SUBJECT: SECOND REQUEST FOR ADDITIONAL INFORMATION ON THE 2009
PERFORMANCE ASSESSMENT FOR THE SALTSTONE DISPOSAL FACILITY
AT THE SAVANNAH RIVER SITE, DOCKET NUMBER PROJ0734

The U.S. Nuclear Regulatory Commission (NRC) staff is currently reviewing the "2009 Performance Assessment for the Saltstone Disposal Facility at the Savannah River Site" (PA) dated October 2009, and the associated documentation. This review is being conducted in accordance with Section 3116 (b) of the Ronald W. Reagan National Defense Authorization Act for Fiscal Year 2005, which requires NRC to monitor disposal actions taken by the U.S. Department of Energy (DOE) for the purpose of assessing compliance with the performance objectives set out in 10 CFR Part 61, Subpart C. The PA is an update to the Performance Assessment performed in support of the "Draft Section 3116 Determination, Salt Waste Disposal, Savannah River Site," dated February 28, 2005.

We have enclosed a second Request for Additional Information (RAI), RAI-2009-02, which is a list of comments for which the NRC staff needs responses from DOE before the NRC can complete its review. The first RAI, RAI-2009-01, was submitted to DOE on March 31, 2010

Figure 1: Tc-99 release over the 10,000-year compliance period based on results
(a) WSRC-STI-2007-00056 and
(b) the 2009 PA model results

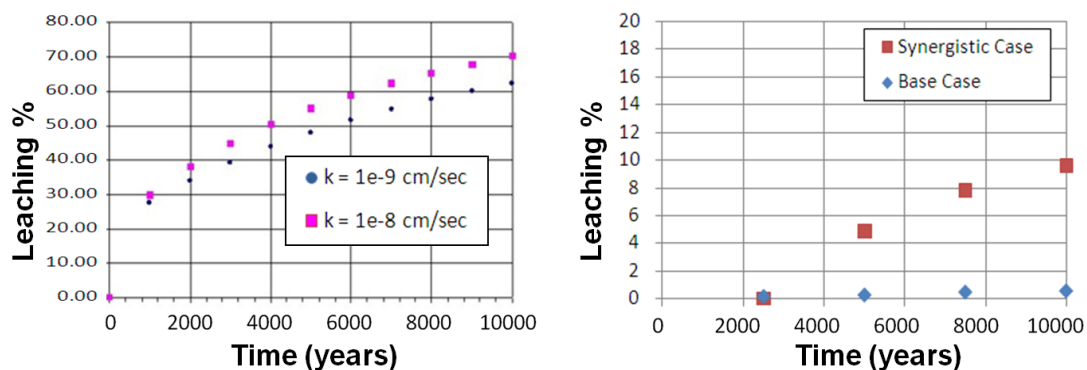
Basis: As discussed in WSRC-STI-2007-00056, experiments on Tc-99 leaching from saltstone simulated grout were conducted and the results incorporated into PORFLOW modeling. Figure 1 shows the modeled release of Tc-99 according to WSRC-STI-2007-00056 and the 2009 Saltstone PA. The modeled Tc-99 release for WSRC-STI-2007-00056 is approximately 60% over the 10,000-year compliance period for saltstone with a hydraulic conductivity of $1\text{E-}9$ cm/s, which is slightly less than the assumed hydraulic conductivity in the 2009 PA of $2\text{E-}9$ cm/s. According to the PORFLOW model files in the 2009 PA, the predicted release of Tc-99 from the saltstone material is 0.6% for the base case and 9.6% for the synergistic case.

transport of gas and liquid-phase oxygen to the fractured vaults and saltstone. In addition, the saltstone grout has been shown to be fractured which would increase the surface area-to-volume ratio, thereby increasing the oxidation of saltstone.

NRC staff recognizes that research is ongoing and that the results presented in Figure 1 below are based on a modeled system. However, this model is parameterized from experimental results conducted with a saltstone simulant whereas the shrinking core model utilized in the PA is less empirical. Additionally, some key parameters of the shrinking core model, such as the $T_c K_d$ are based on a formulation that is drastically different than saltstone (see SP-15).

Path Forward: The PA should be consistent with relevant research or justification should be provided discussing why it was excluded. Provide any additional references on Tc-99 leaching from saltstone that have not already been provided to the NRC.
